Notice for Switch Parts of Movable Core Support

Subject	Notice for Switch Parts of Movable Core Support	Date of issue	September 22, 2021
		MITSUBISHI ELECTRIC FA INDUSTRIAL PRODUCTS CORPORATION 1-1-1 Imajuku-Higashi, Nishi-ku, Fukuoka 819-0192 TEL 092-805-3631

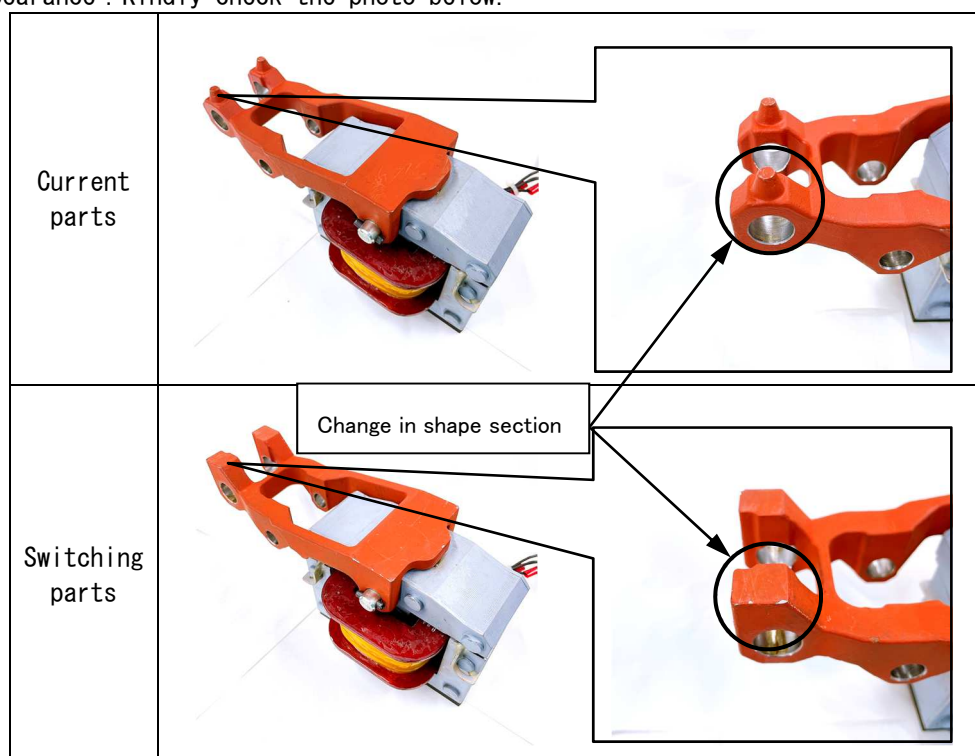
For quality improvement purpose, shape of movable core support will be partially changed accordingly.

Countermeasures against removal of snap pin when closing the electromagnet box lid.

▪ Dimensions : There is no change in the main dimensions.

▪ Compatibility : Compatible in assembly. No change in assembly method.

There is no problem of using current and switching parts. (10t or more)

▪ Appearance : Kindly check the photo below.
